# Groundwater Review and Assessment Report

February 2019

# Historical Groundwater Review and Assessment Austar Coal Mine

Prepared for  
Yancoal Australia Pty Limited

**Figure 4.2 Groundwater head all sites but EX01H**

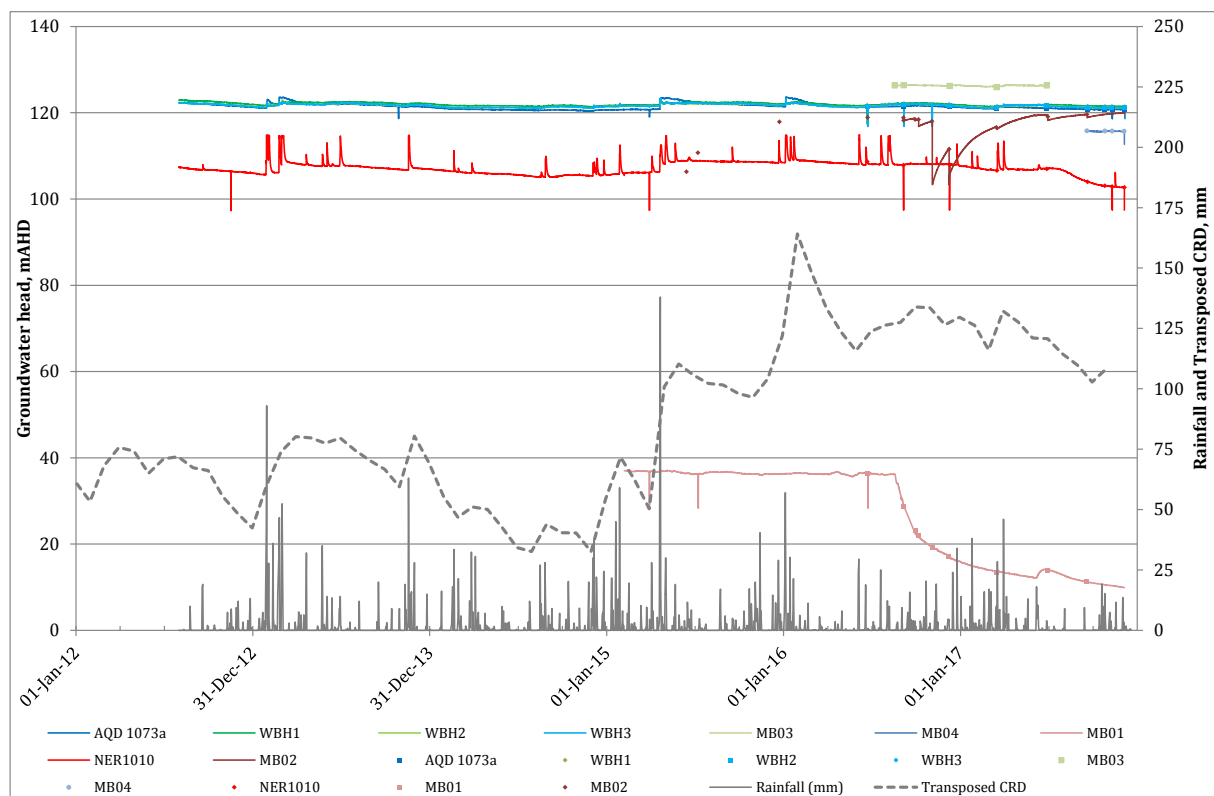
- Heads in the alluvium are between 115 and 130 mAHD and appear to be stable with no mining induced impacts apparent.
- Heads in the Branxton Formation vary widely between 10 mAHD (MB01) and 120 mAHD (MB02 and NER1010) and show either a declining trend (MB01 and NER1010) or a trend that is suppressed by long recovery curves from the previously used purging technique for sampling at MB02. NER1010 has a lot of spikes which could be either errors or real pressure spikes such as external loading effects. The most important feature in Figure 4.2 in the Branxton Formation is the very low head in MB01. The head was approximately 36 mAHD prior to August 2016 and has declined since to about 10 mAHD by late 2017. Regardless of the decline, the head in MB01 is significantly lower than those in NER101 or MB02.

- Other important features in Figure 4.2 in the Branxton Formation are two different declines in head:
  - In MB01, the head declined from 36 m AHD to approximately 10 m AHD since August 2016. It is understood this decline may have been triggered by a vibration event related to mining and may have re-activated a preferential groundwater flow path near a fault.

- NER1010 is located approximately 500m north of the current workings and between the main headings and LWB5 (refer Figure 4.1). In NER1010, the head declined from 107 mAHD to approximately 103 mAHD since June 2017. AGE (2017b and 2017c) attributes this decline as probably to mining, noting that:

**Figure 4.5 Groundwater EC**

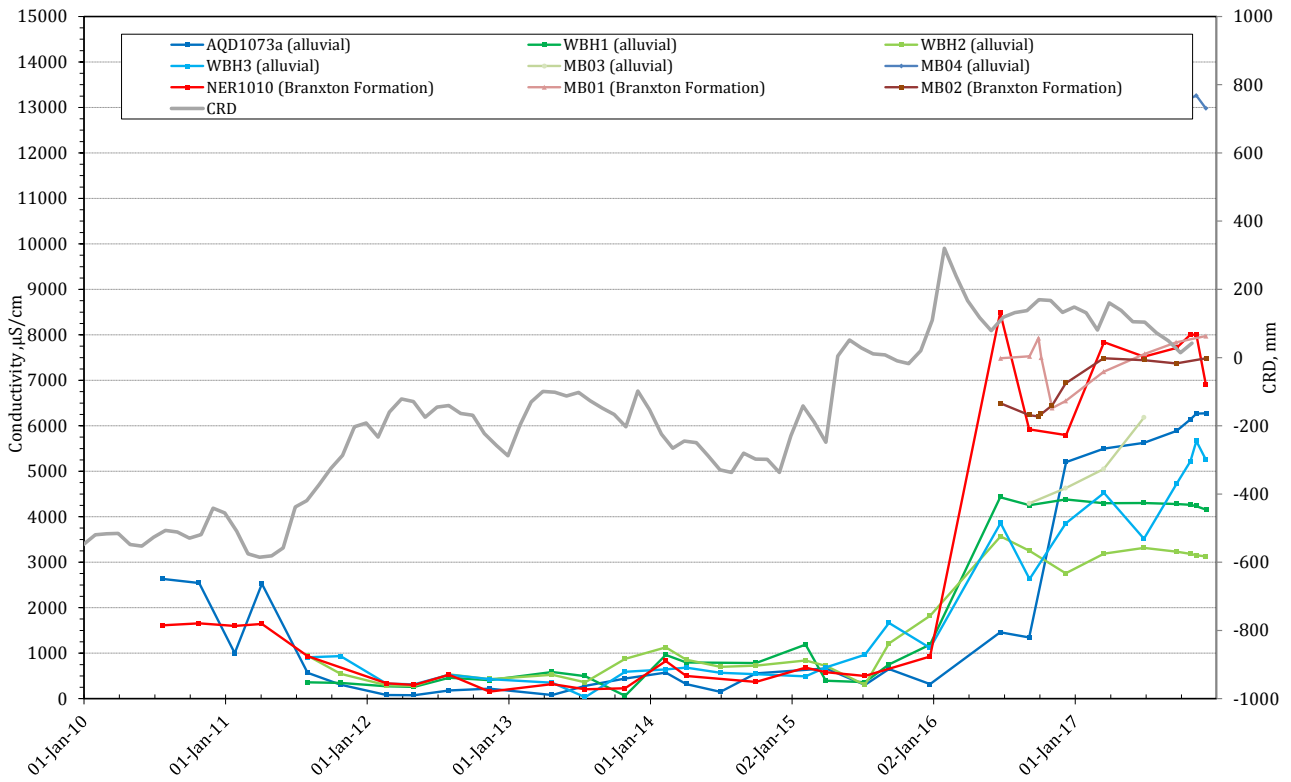
- It is understood that the sampling methodology has changed since 2016. Since 2016, the new bores MB01 and MB02 are sampled using hydrasleeve and the alluvial bores are purged. Previous purging caused large drawdowns and long and incomplete recovery in the low hydraulic conductivity materials, such as MB02 (Figure 4.2). Since 2016, alluvial ECs are between 3000 and 6000  $\mu\text{S}/\text{cm}$ , prior to 2016 they were in general less than 1500  $\mu\text{S}/\text{cm}$ .

- It is very unlikely that mining activity would cause such a sudden, simultaneous and large change in EC in all monitored bores, including those in the alluvium the groundwater head of which do not show mining impacts. This conclusion is consistent with Dundon Consulting (2017; with additional reasons provided in Comment No.7 of Section 3.1.5 of this report).

- It would be prudent in the future not to analyse the results of field groundwater quality using the pre-2016 and current sampling methodologies together. Once more data are available, only the results from 2016 onward could be analysed.

Figure 1: E C - Austar's Alluvium Monitoring Bores and Dol-Water's Monitoring Bores

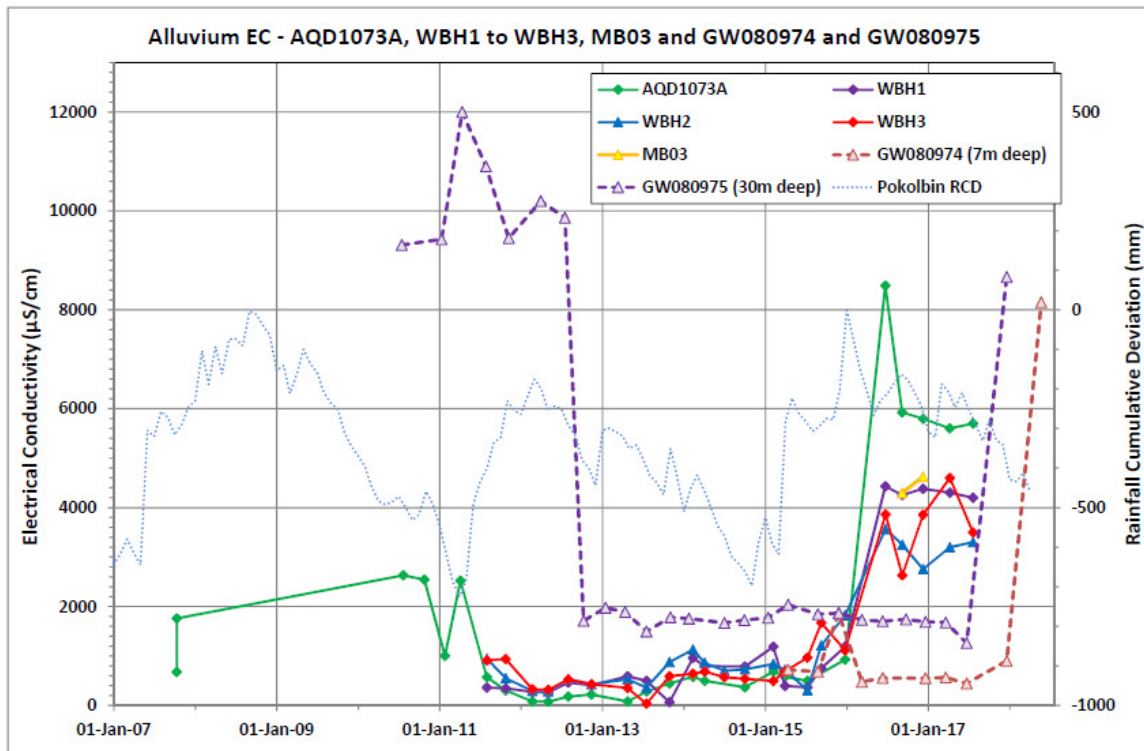
In reply to Mr Dundon's assessment it is noted from Figure 1, Attachment A, that visually the low salinity observations do not correlate with the rising trends of Pokolbin RCD (Rainfall Cumulative Deviation) trend line, that is, periods of wet climate when sheet runoff is likely to occur. The data could be explored statistically to draw out any significance between climate

The ACM and Department alluvial bores are at shallow depths with only small casing storage volumes (i.e. 10-20 litres). Hence, purging of these bores would be a relatively quick event and thus if there were particular issues with the previous contractor purging duration being inefficient, then greater variability would be anticipated, particularly if there was any stratification. In effect, Figure 1 in Attachment A presents the opposite with more stable conditions under the previous contractor and more erratic nature in the later sampling events.

**Figure 1**

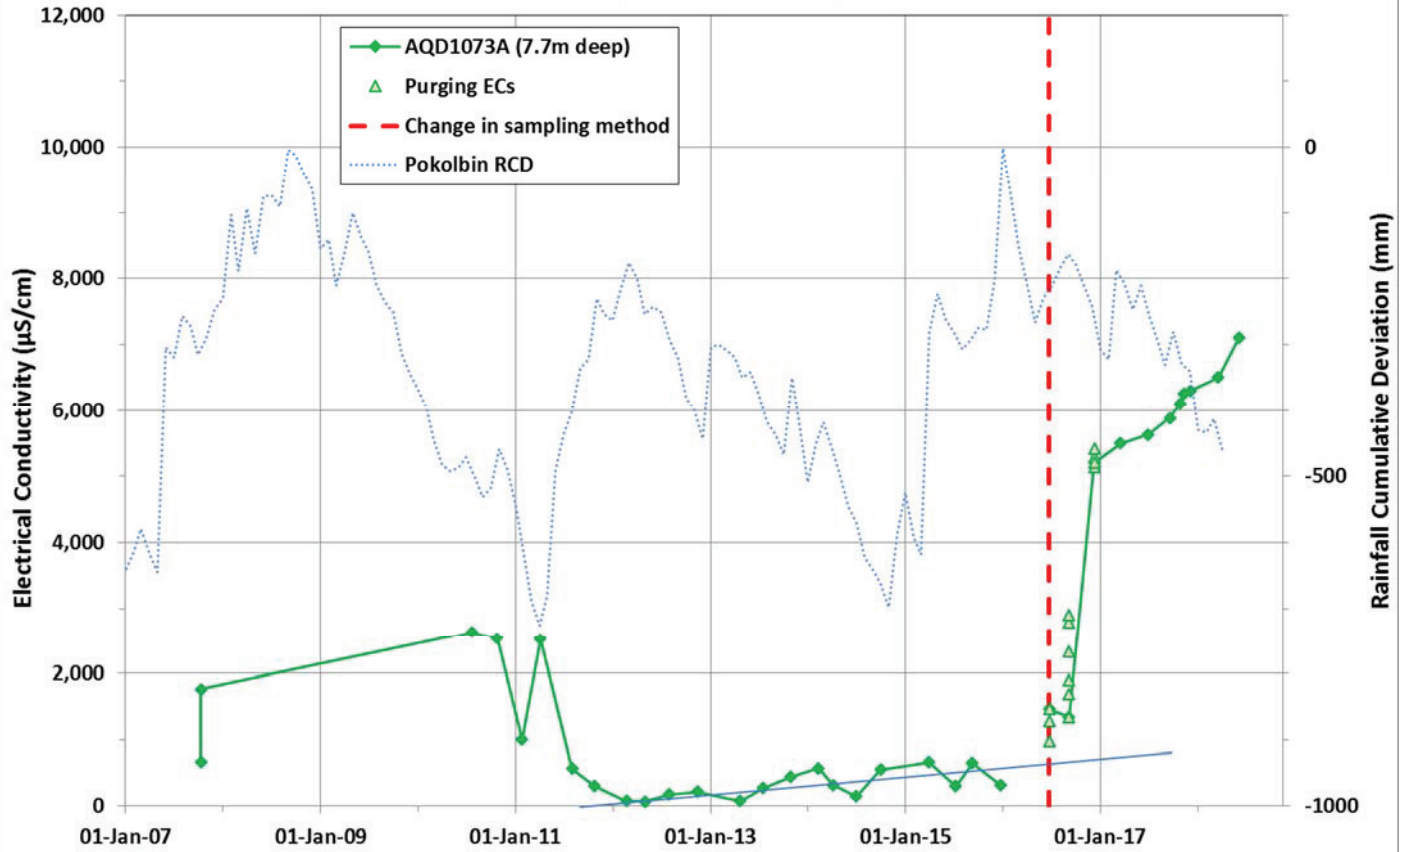
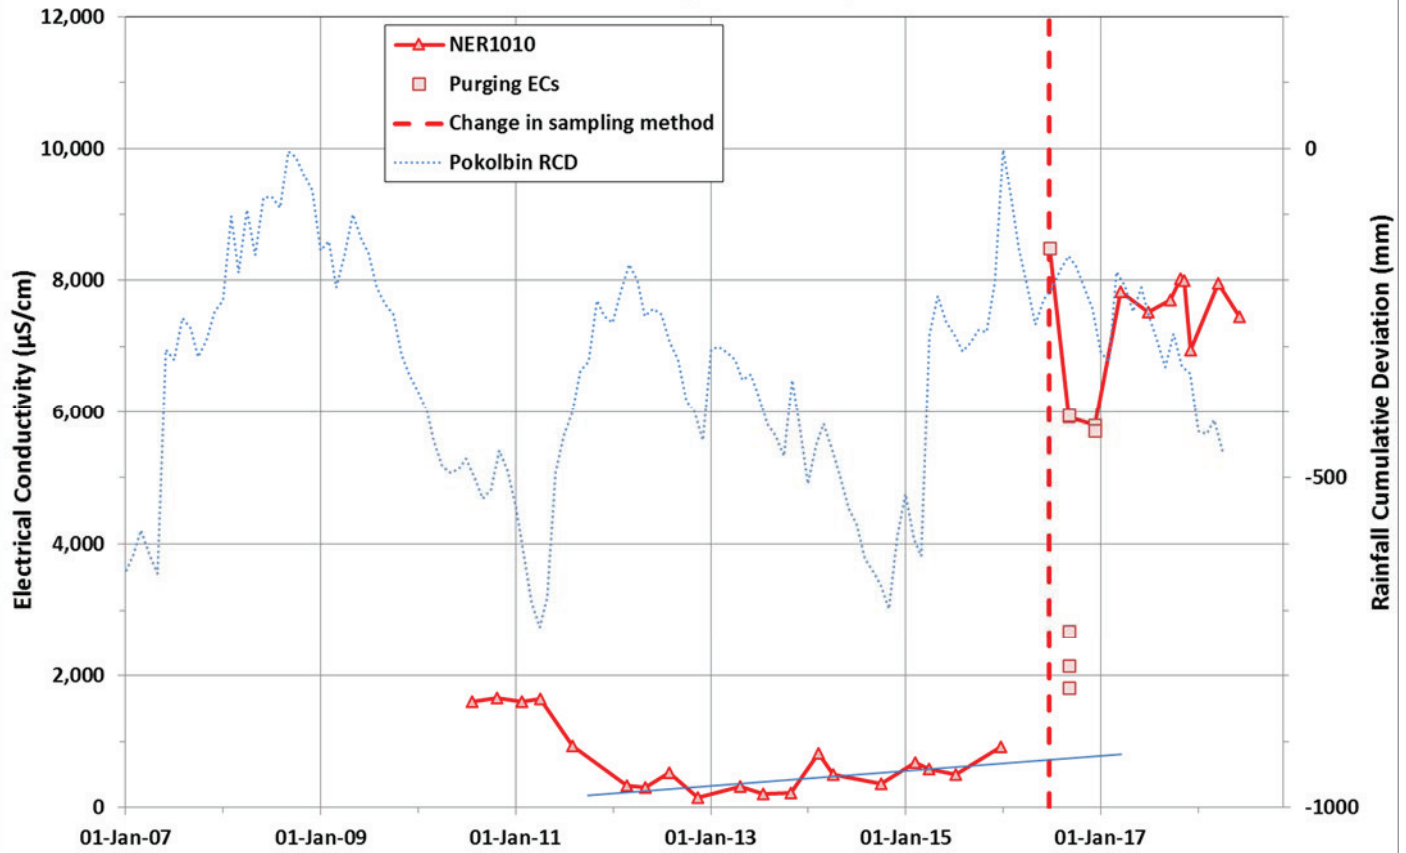
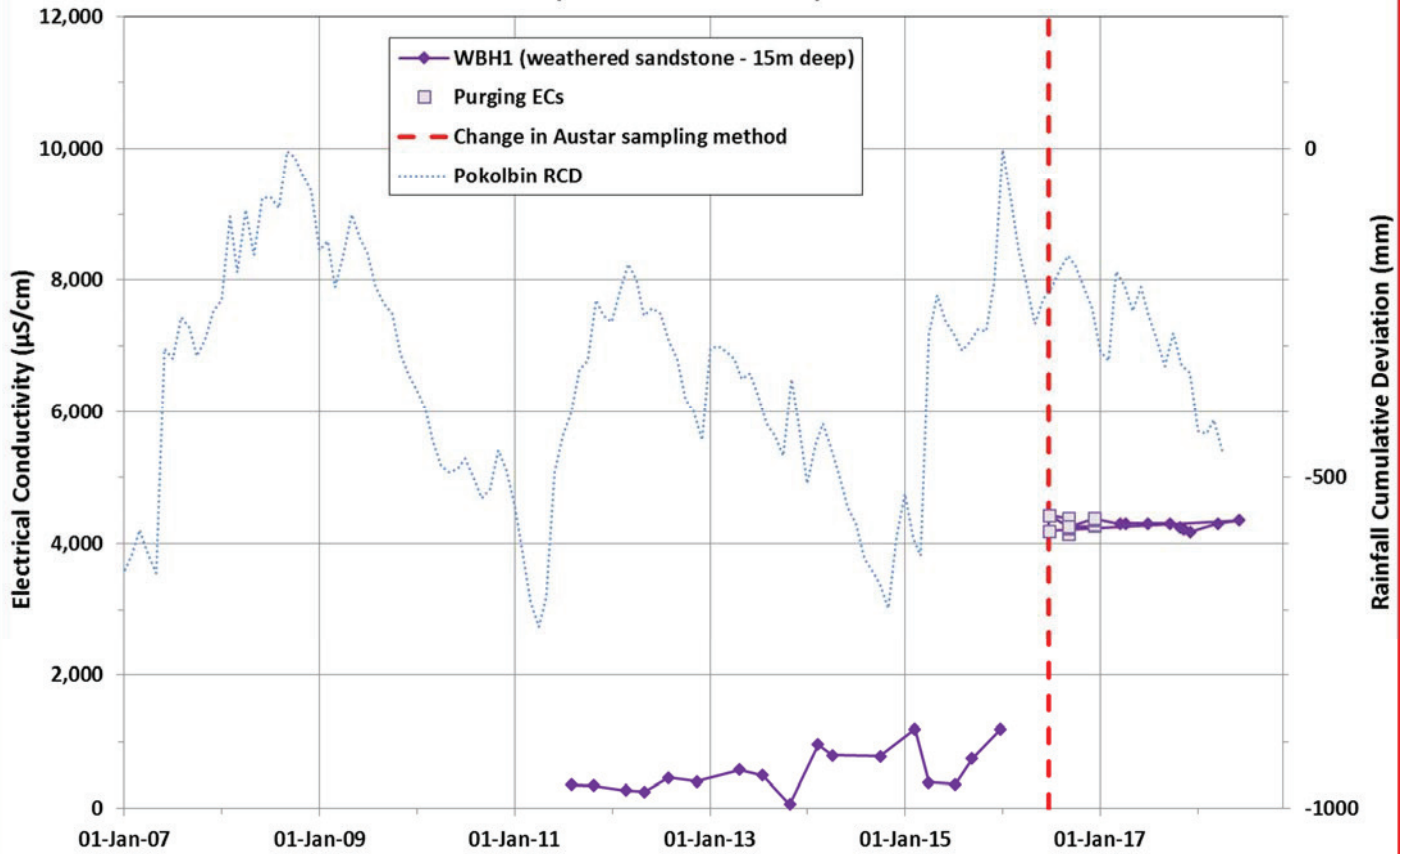
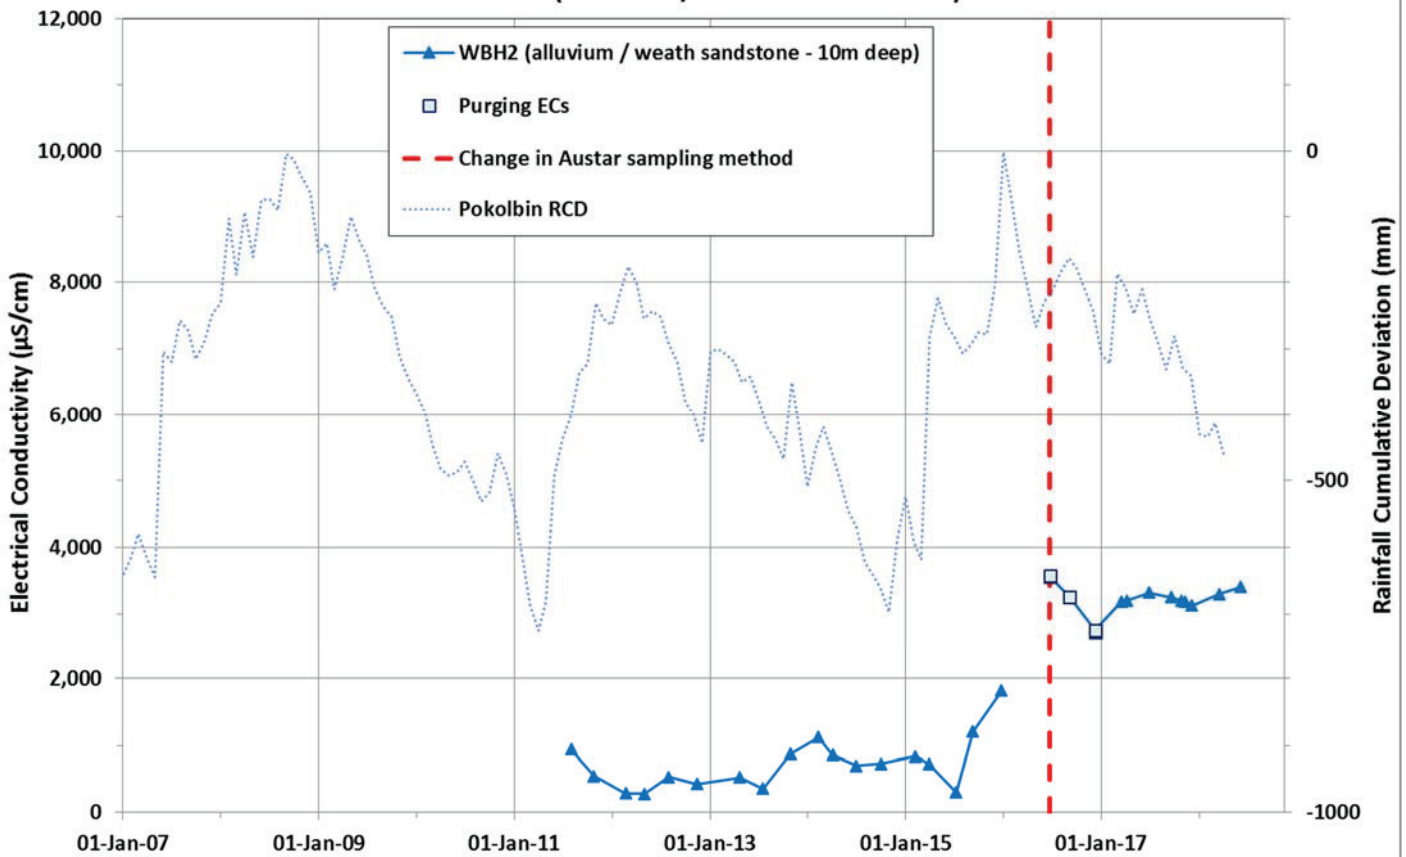
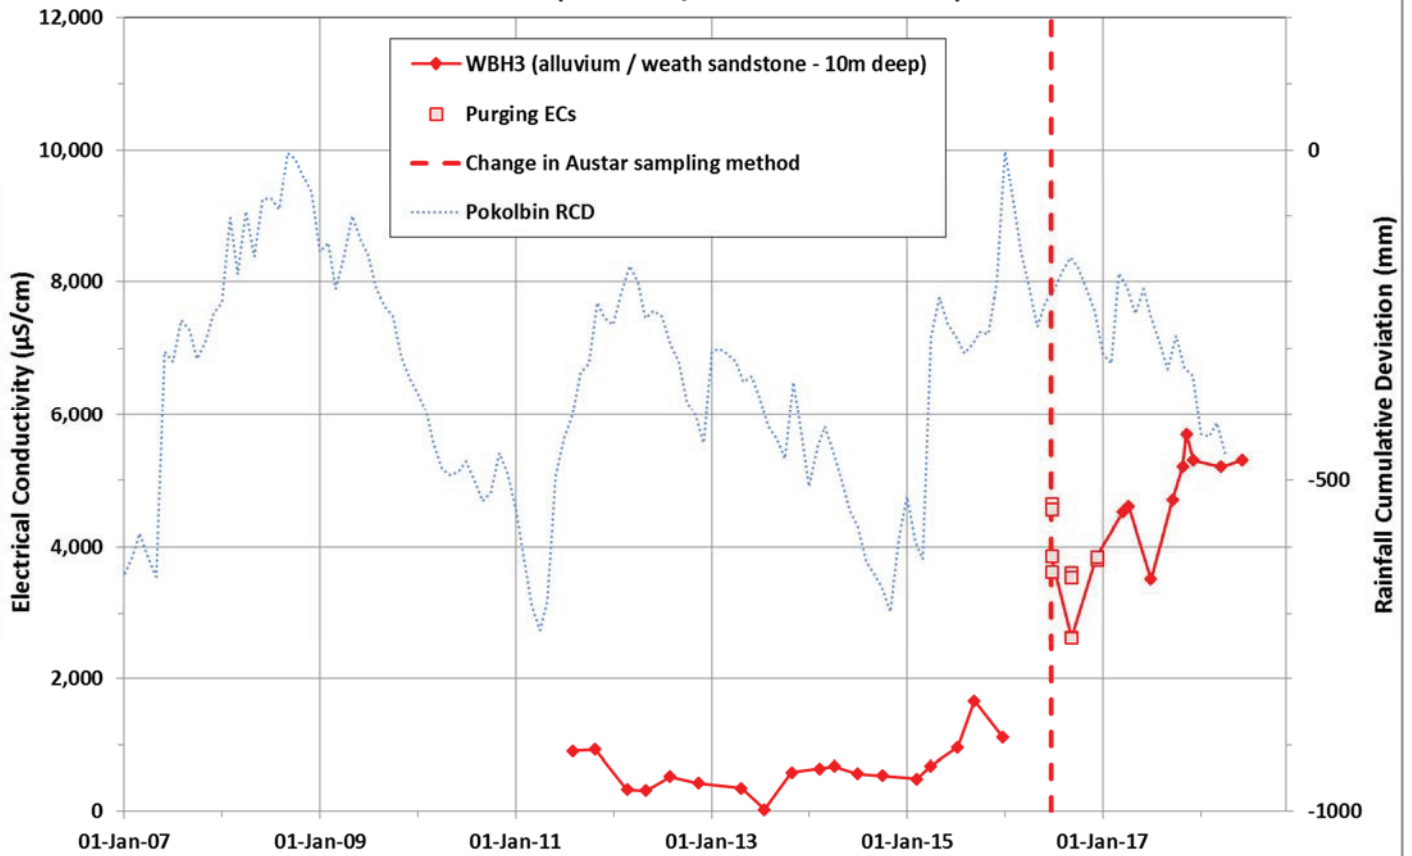
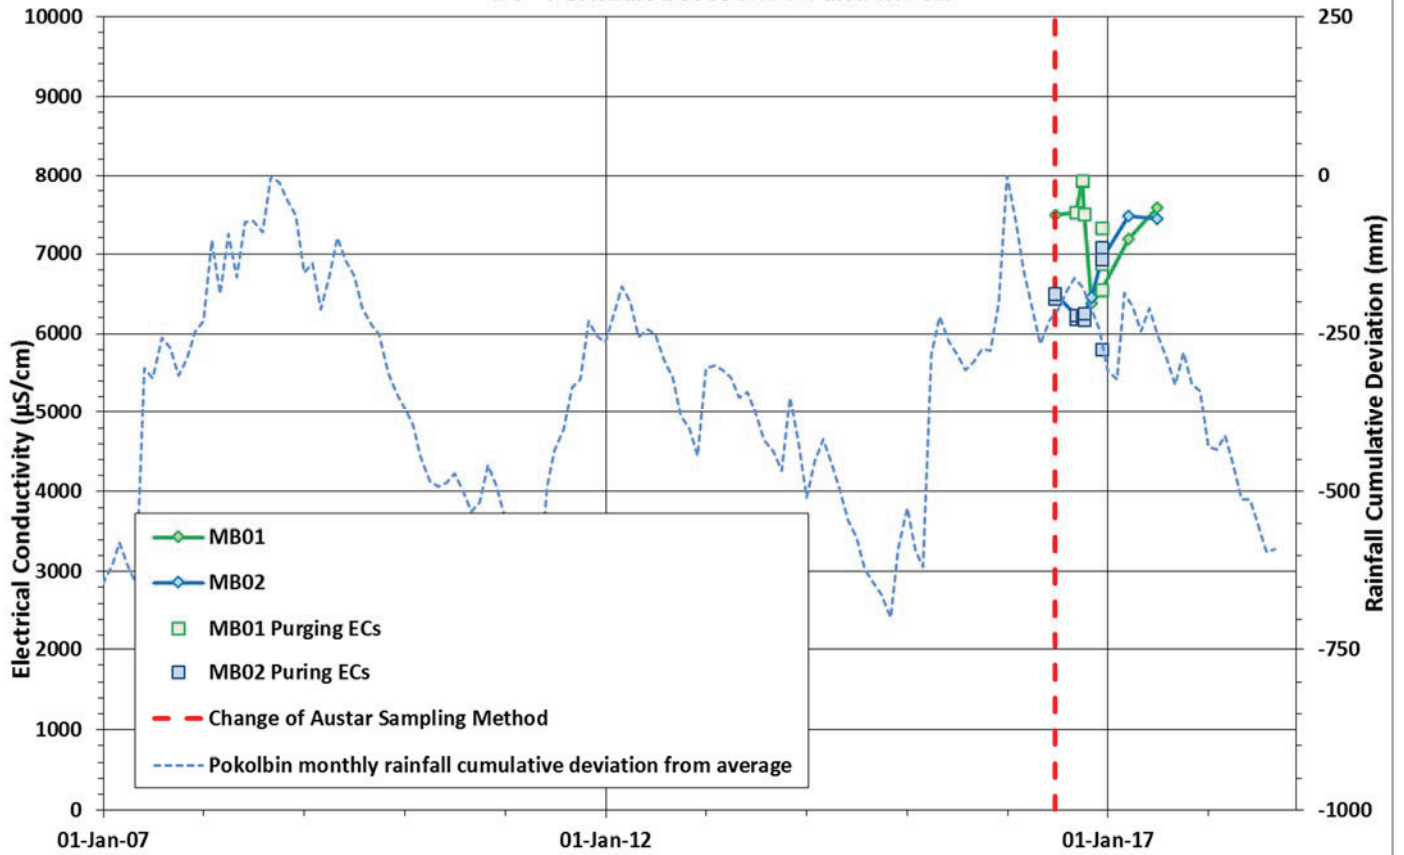
The monitoring data also show that in addition to the abrupt increase in salinity, three of the Austar bores are currently displaying a rising trend in EC – ADQ1073A, WBH3 and MB03 (until monitoring ceased). This may be related to the declining trend in rainfall as displayed by the RCD trend over the period 2016 to 2018 (see **Figures 1 to 5**).

Although we are satisfied that there has not been a change in groundwater beneficial use, I recommend that some additional sampling and lab analysis be undertaken for the next 12 months to better understand the groundwater chemistry in the Quorrobolong Valley area, as follows:

- Continue quarterly sampling of all bores currently being monitored.
- Prior to purging, collect an initial sample each bore from just below the water level. Then undertake purging as currently being performed, before collecting a second sample from near the base of the screened interval as is being done at the present time.

- Submit both samples for laboratory testing of basic parameters (EC, pH, TDS) and for major ions (Ca, Mg, Na, K; Cl, SO<sub>4</sub> and CO<sub>3</sub>/HCO<sub>3</sub> alkalinity).
